KOLKATA PORT TRUST

HALDIA DOCK COMPLEX

Tender No.: SDM (P&E)/T/34/2018-19

♠ ADDENDUM-III ♠

Annexure-V

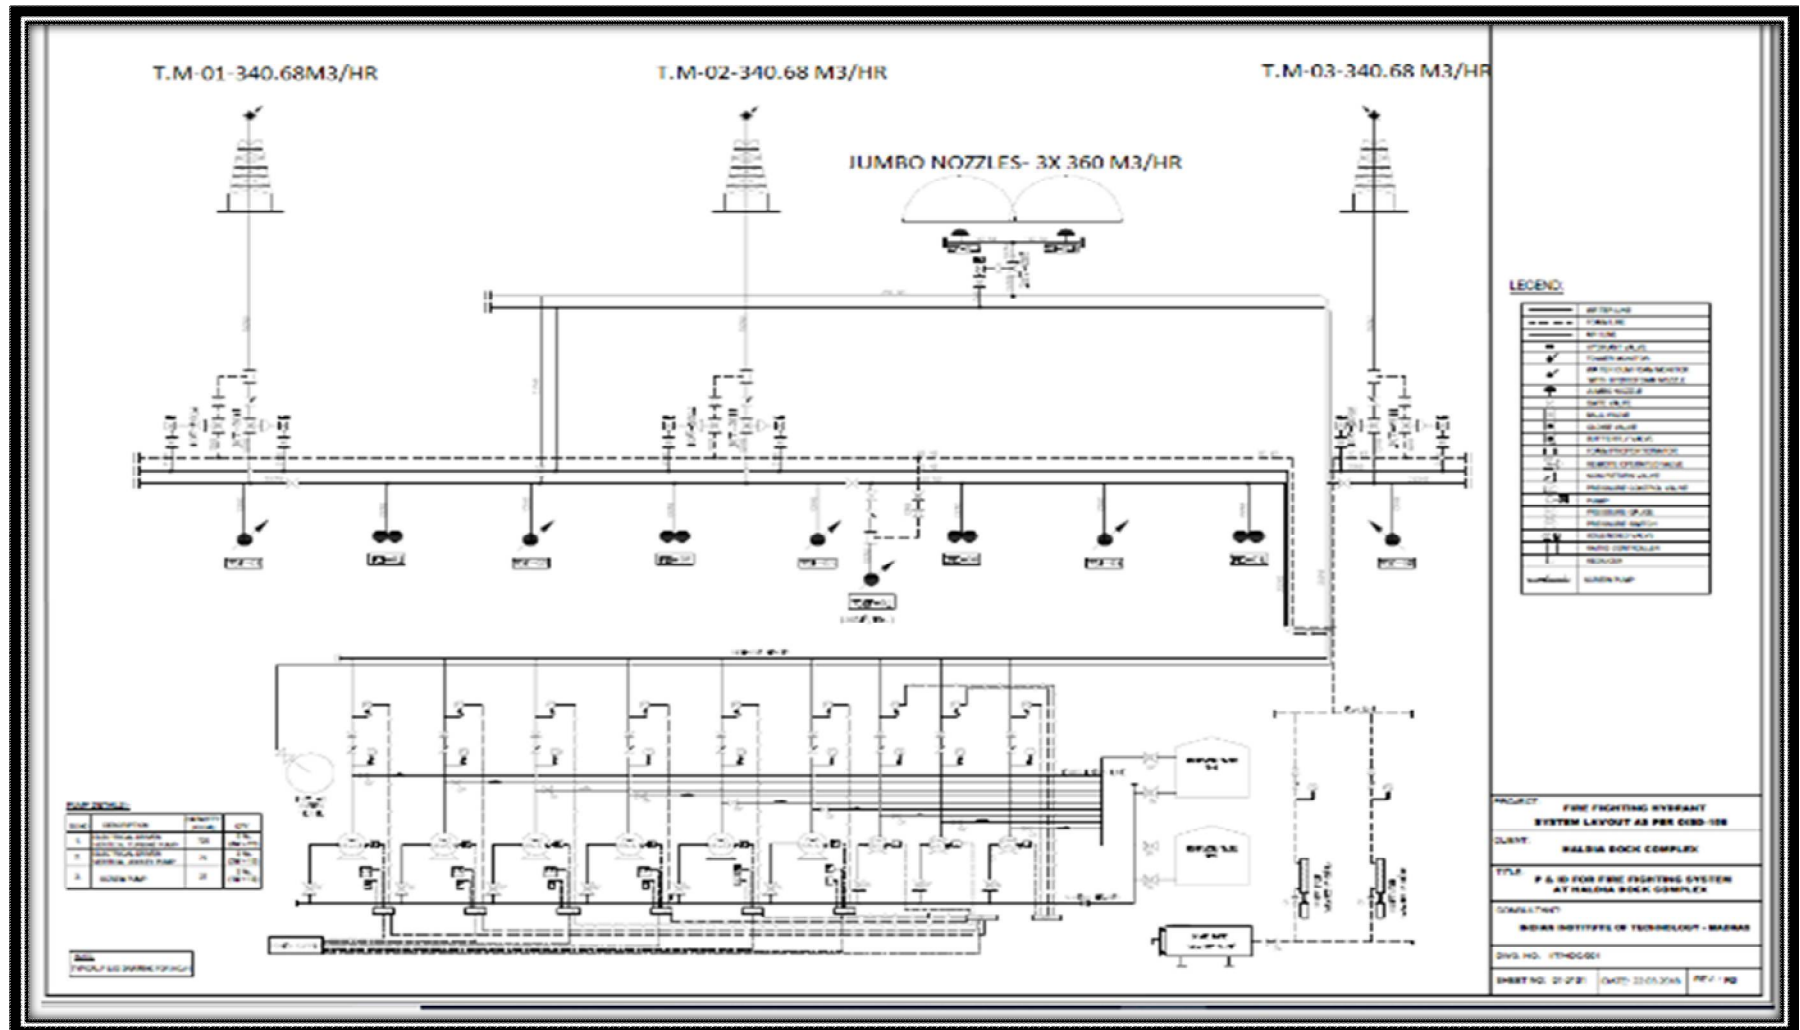
63.	General			Supply of Foam pipe:	Kindly provide schematic for foam storage & distribution system	P&ID for fire fighting system enclosed as Annexure-V in Addendum-III may be referred.

SLD COMMUNICATION SYSTEM

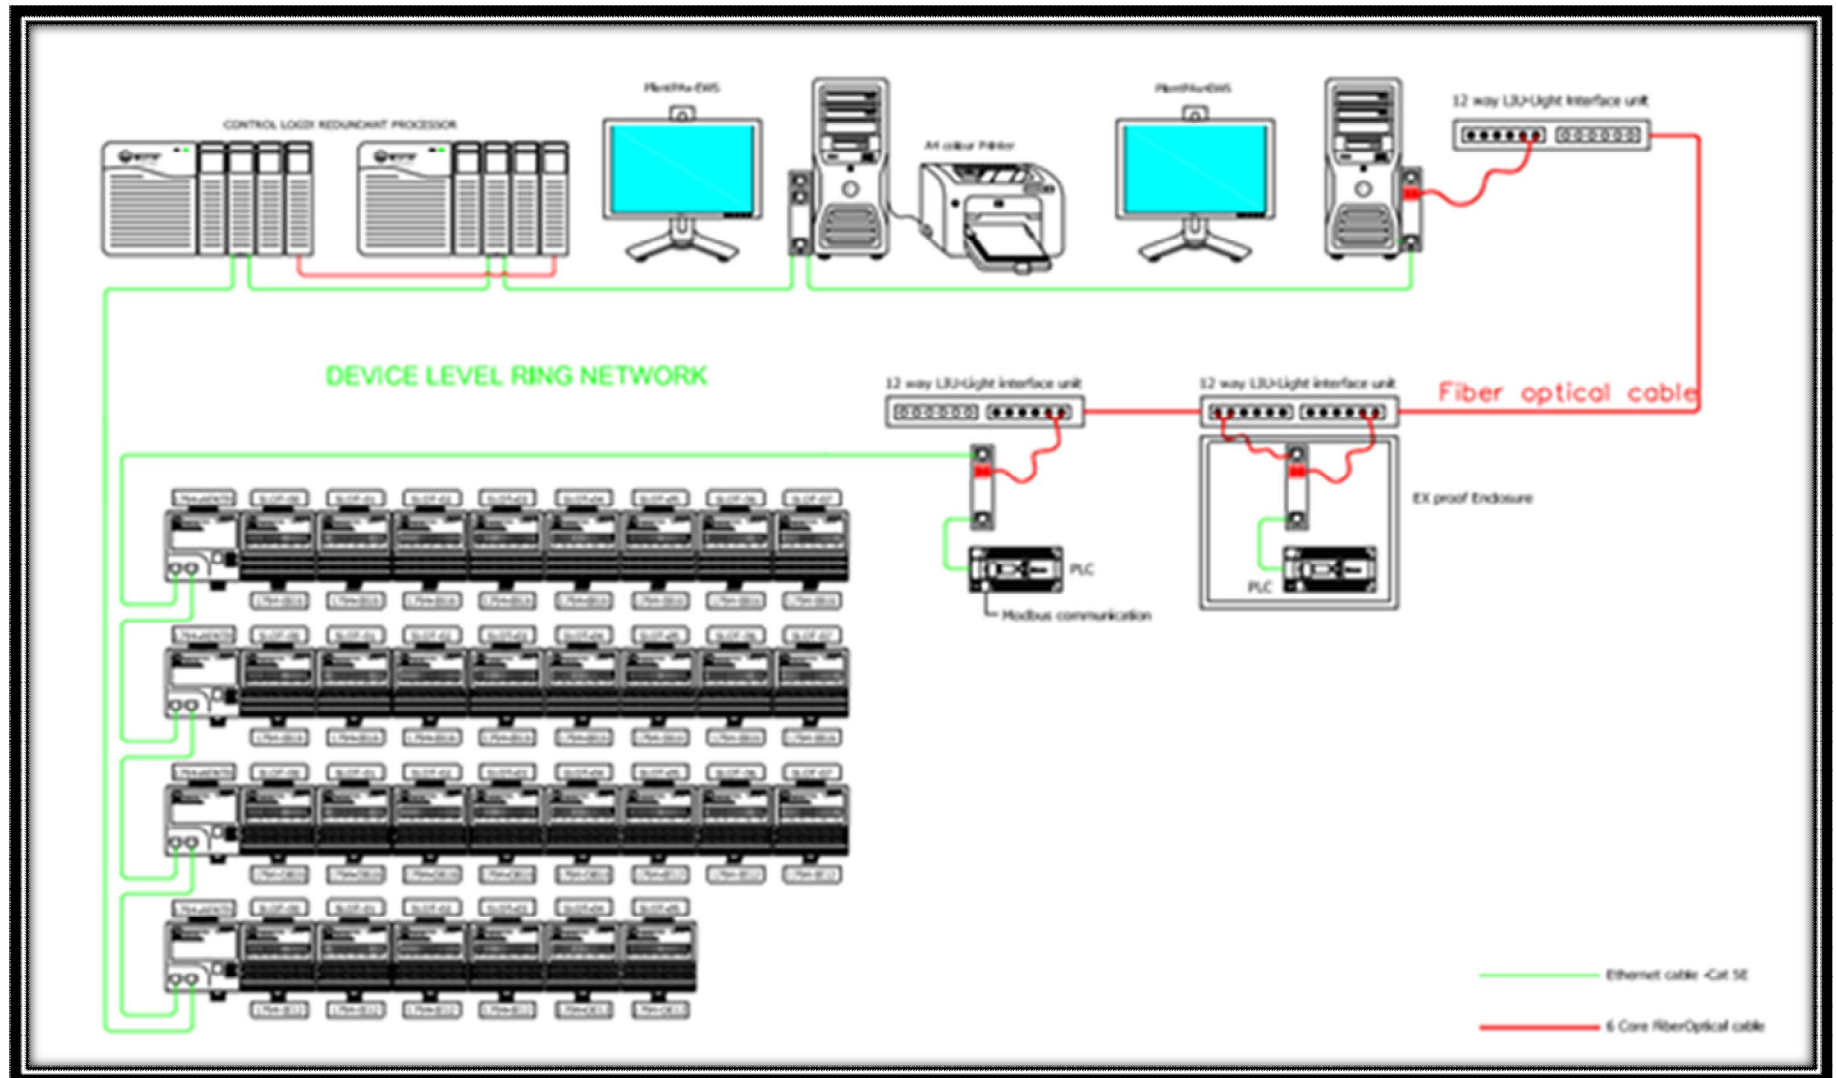
38.	Vol. 2	57	Section 3, Clause 3.15.3	Communication System:	Kindly provide detailed specification of communication system. Also provide the schematic/SLD for communication system.	SLD of communication system attached as Annexure-VI in Addendum-III.
